Addendum No. 1

TRAFFIC SIGNAL & ADA IMPROVEMENTS

**TOWN OF ADDISON, TEXAS
PUBLIC WORKS AND ENGINEERING SERVICES
BID NUMBER 22-133**

06/16/2022

Landscape Paver Specifications

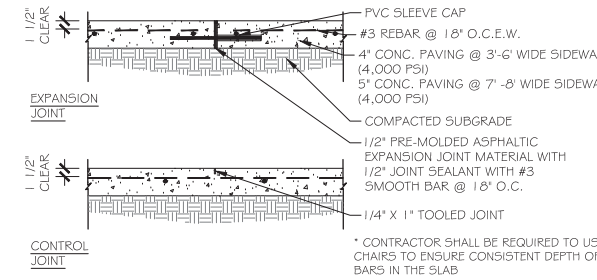
Landscape pavers are proposed for installation at Belt Line Road & Addison Road and Belt Line Road & Beltway Drive. Per Town of Addison, landscape paver type, color, and pattern shall match the specifications from the Belt Line 1.5 project.

See detail 4 on the following page (L1.14) for paver specifications and sheet L1.11 for an example layout. The photos below also illustrate the paver type, color, and pattern.

PER TOWN OF ADDISON, LANDSCAPE PAVERS SHALL BE HANOVER PLANKSTONE PAVERS. SEE PROJECT MANUAL FOR ADDITIONAL DETAILS ON PAVES COLOR AND DIMENSIONS.

**TRAFFIC SIGNAL PLANS
 PROPOSED PEDESTRIAN RAMPS
 AND PAVEMENT MARKINGS**

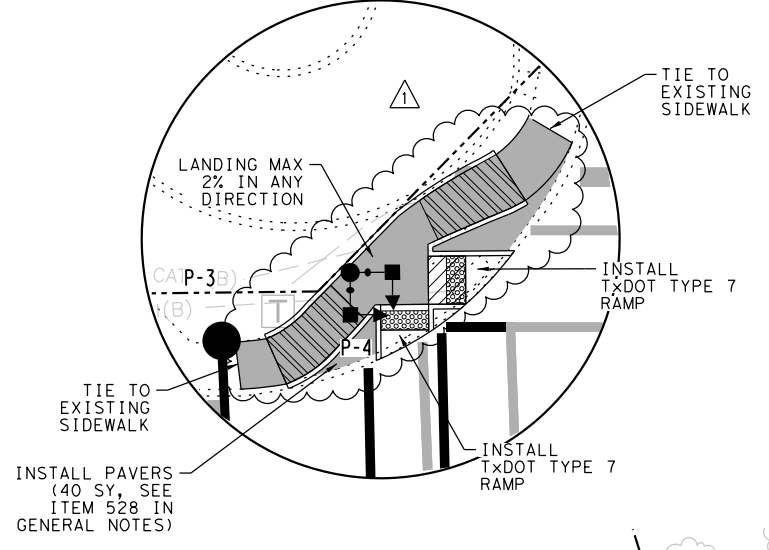
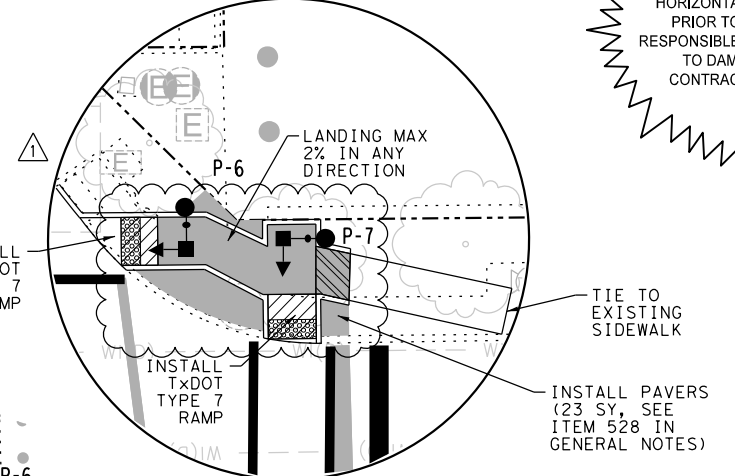
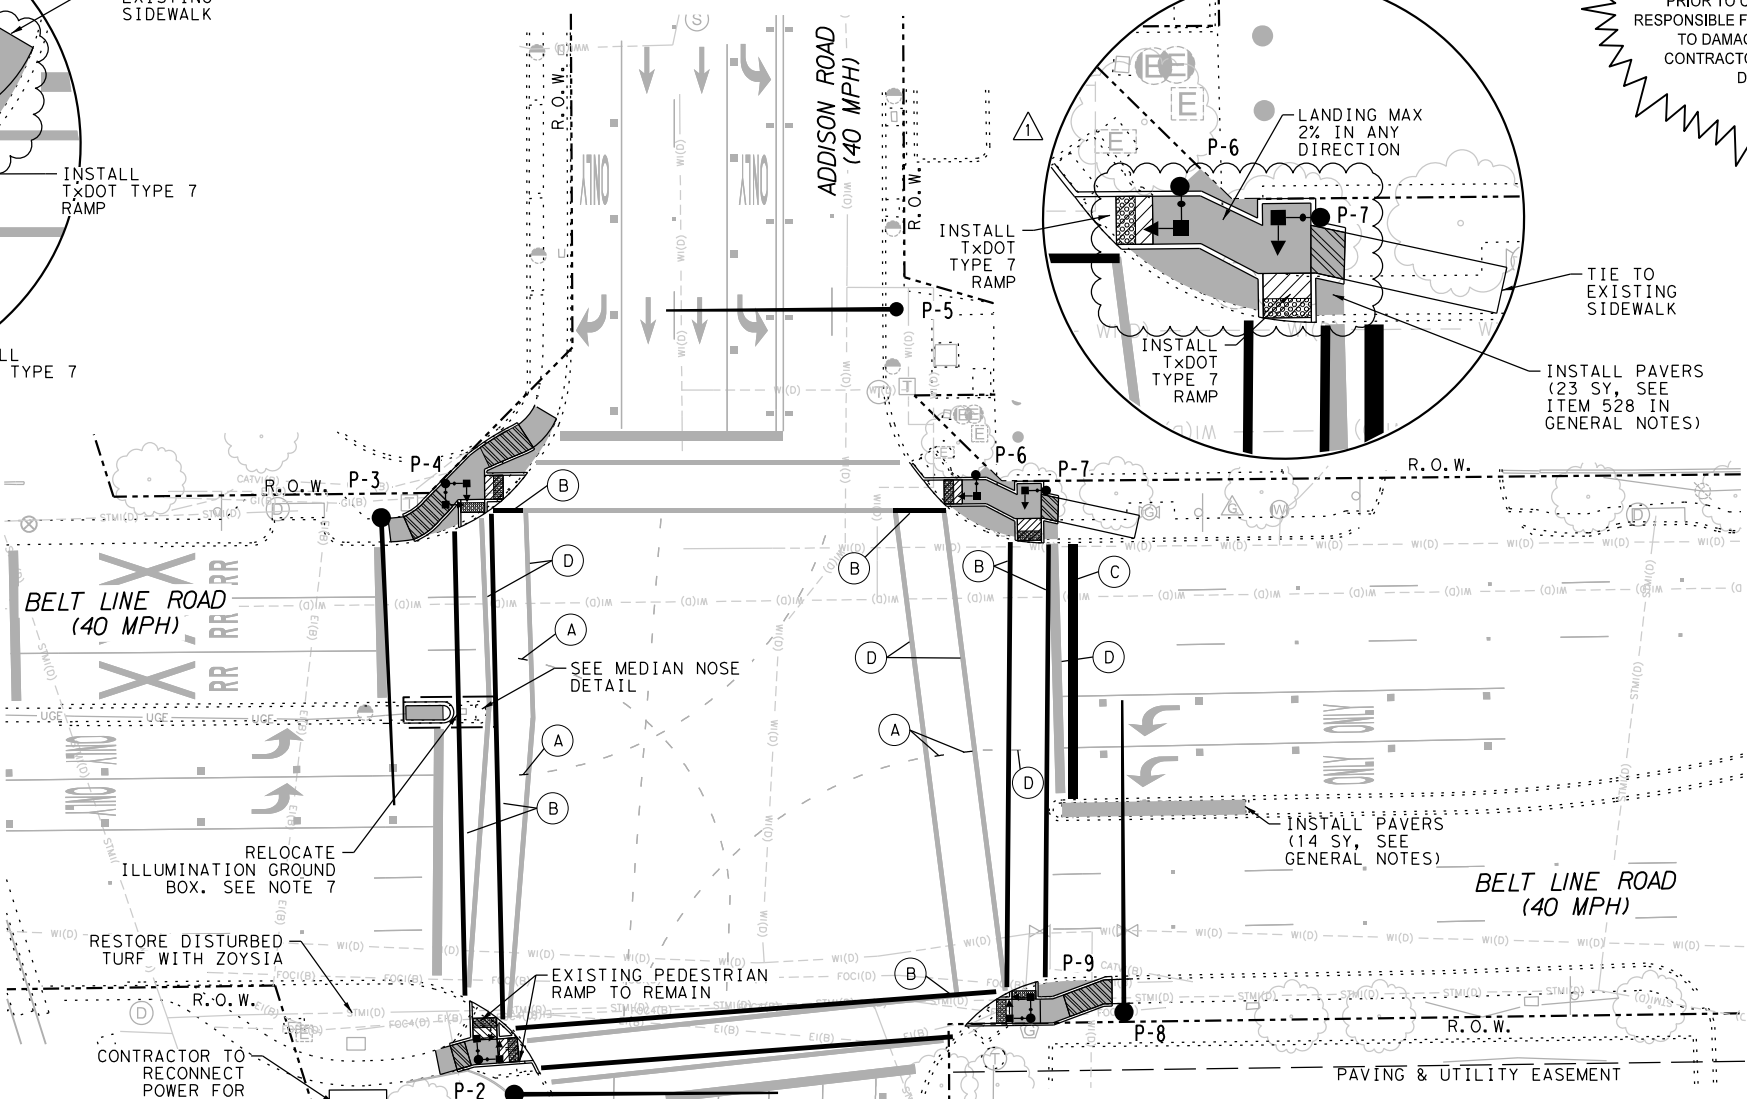
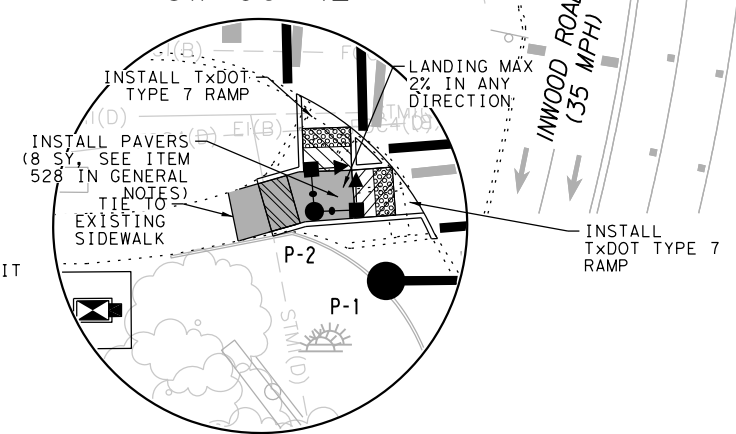
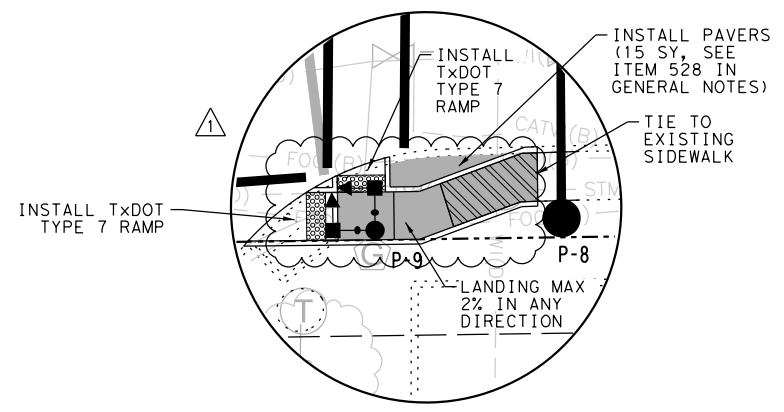
1. REPLACE PLAN SHEETS 5, 11, 17, 43, and 43 with the plan sheets attached. Revisions were made to show curbed areas of pedestrian ramps and adjust sidewalk for pedestrian pole clearances and ramp landings. Revisions have been noted on each sheet.

- PROPOSED CURB RAMP LANDING SHALL BE POURED UP TO THE SIGNAL FOUNDATION, LEAVING NO GAPS.
 - CONTRACTOR SHALL ENSURE THAT ALL PED RAMPS DRAIN TOWARDS THE STREET WITHOUT PONDING IN THE RAMP OR GUTTER AREA.

- RAMP LANDINGS SHALL NOT EXCEED 2% MAX CROSS SLOPE AND 2% RUNNING SLOPE. PROPOSED SIDEWALKS SHALL NOT EXCEED 2% MAX CROSS SLOPE AND 5% RUNNING SLOPE.
